Bays 1-4a Locomotive Workshop,
Australian Technology Park, Eveleigh

Submitted to Department of Planning &
Environment

On behalf of Mirvac Projects Pty Ltd

Figure 3 Maximum extent of the service riser zone

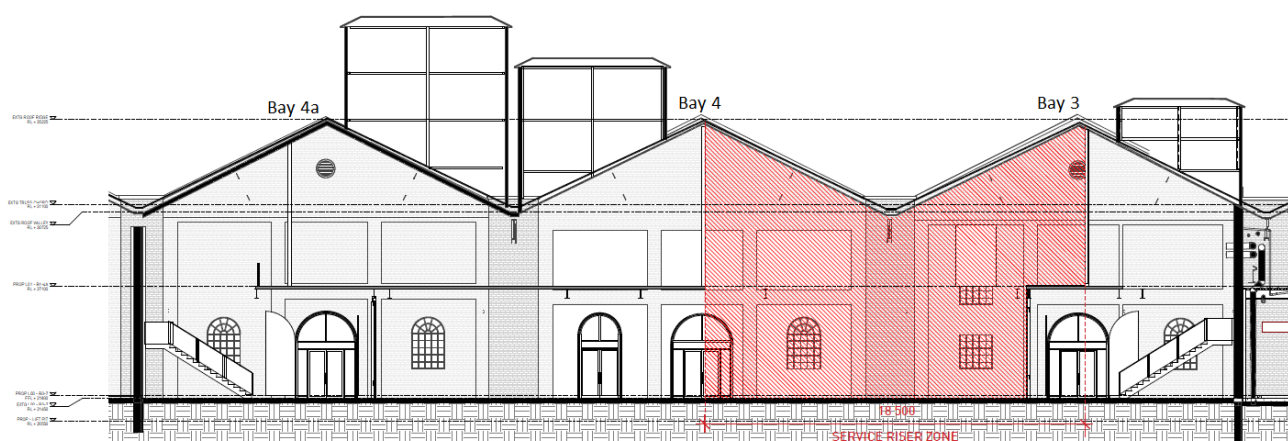
The Department has asked for further information in regard to the major service needs, such as connections to roof plants, lifts installation, etc, particularly for the supermarket.

As noted in the Response to Submissions Package, prepared by Sissons (**Appendix M**), throughout the Locomotive Workshop, the majority of the pipework and cabling will be reticulated through a consolidated service run around the perimeter of the building, similar to the existing situation. Services required to be reticulated from the new roof plant platforms over Bays 3-4a will do so via a service riser located within the northern wall between Bays 3 and 4. **Figure 3** illustrates the maximum extent of the service riser zone, which corresponds to the back (northern boundary) of the retail tenancy in Bays 3-4a north. Whilst it is anticipated that the riser will be boxed in by a dry wall system, the exact location of the service riser, the materials that will use to box it in and the end appearance of this zone will be determined in conjunction with the fit-out design for the retail tenancy. The provision of the service riser will be designed to minimise any impact upon the northern heritage wall physically.

Figure 23 Artistic Impression of the new access stair with an interpretive backdrop

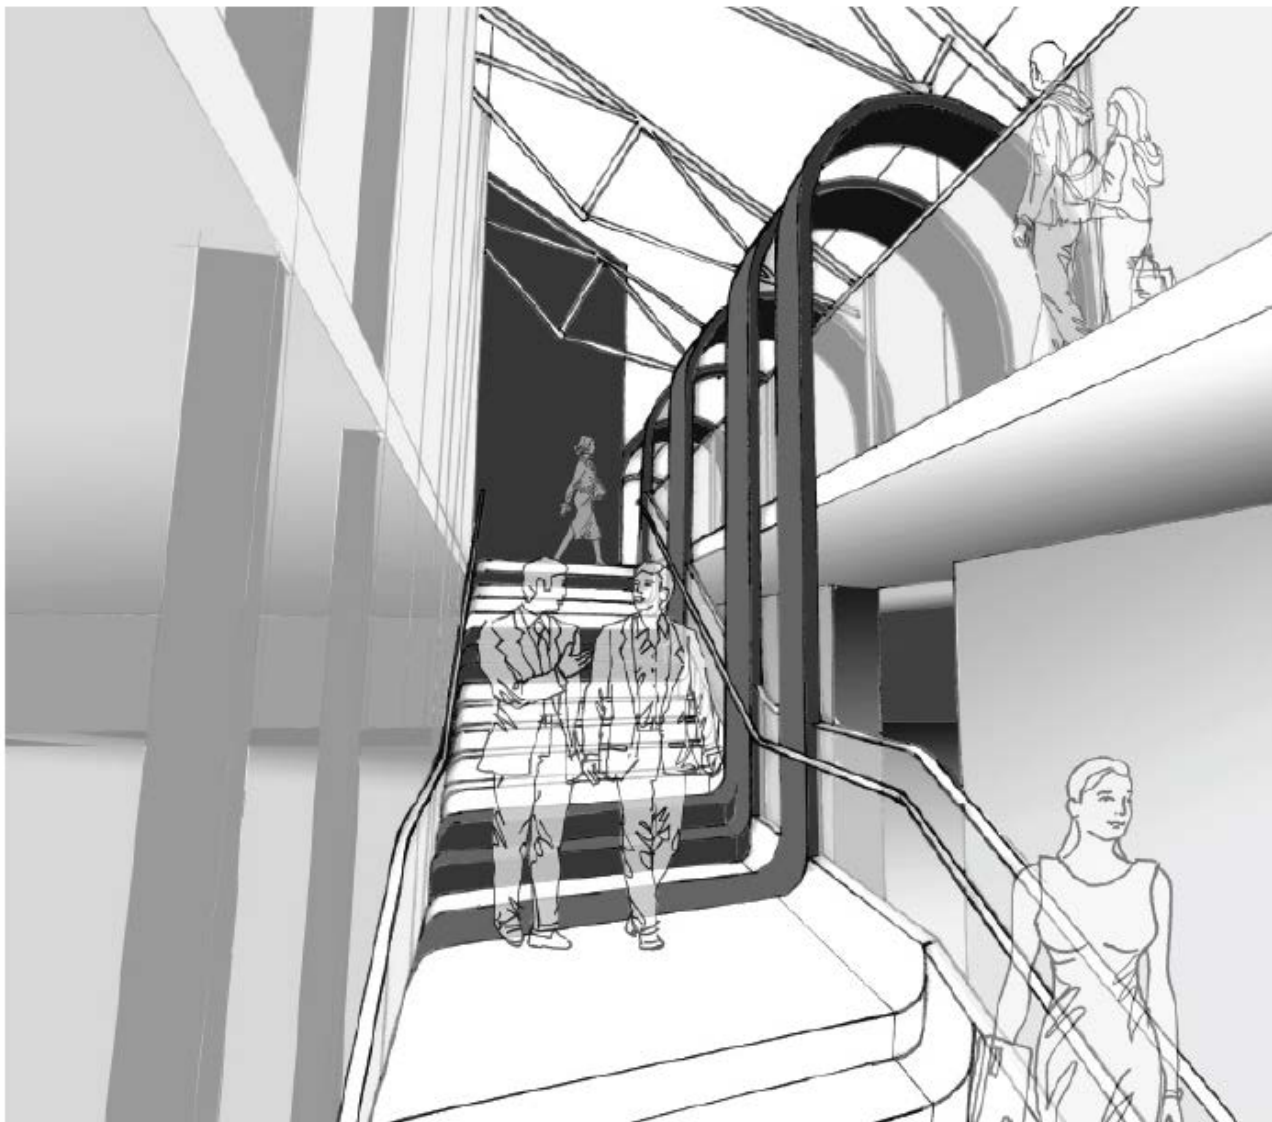
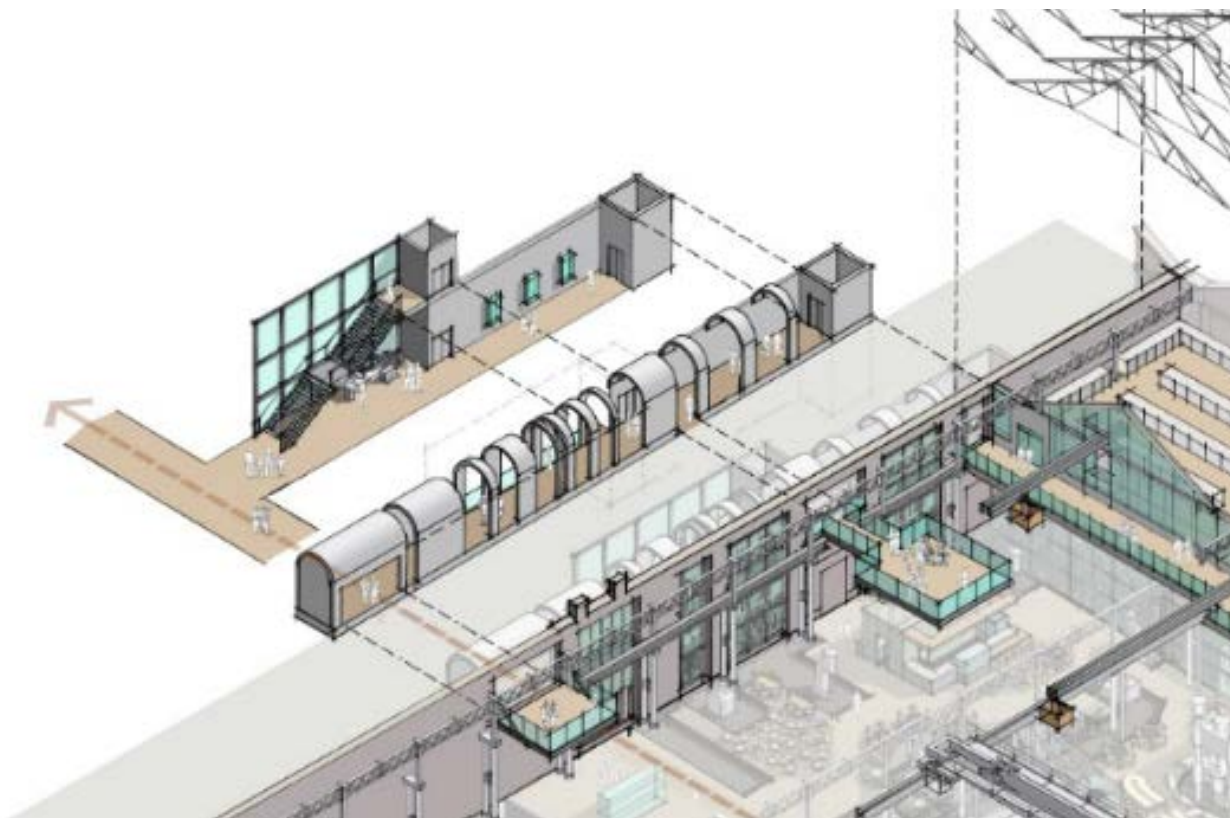
The City of Sydney has recommended that the lift and stairs that access the Mezzanine Level be co-located adjacent to each other to provide equitable access options from the Ground Floor to the interpretation space on the first floor, they also request the co-location of the access options must avoid or minimise material and heritage impact on the physical fabric and on the quality of significant spaces. In addition, the Heritage Council also requested the co-location of the stairs and lift but propose that the facilities should be provided in Bay 2.

Mirvac's design team then reviewed the potential to make a feature of the new stairs and expand the vision for this space. As described in **Section 4.20**, the revised design provides a new stair and walkway that will incorporate a heritage interpretation zone and provide access to the Mezzanine Level but also a new viewing platform over the Blacksmith area in Bay 2.

The revised design provides a generous new 'feature' stair and access lift (within Bay 3) that is adjacent to the wall between Bays 2 and 3. Both the stair and lift are accessed directly from the central spine in Bay 3 and will be clearly visible on approach from either direction.
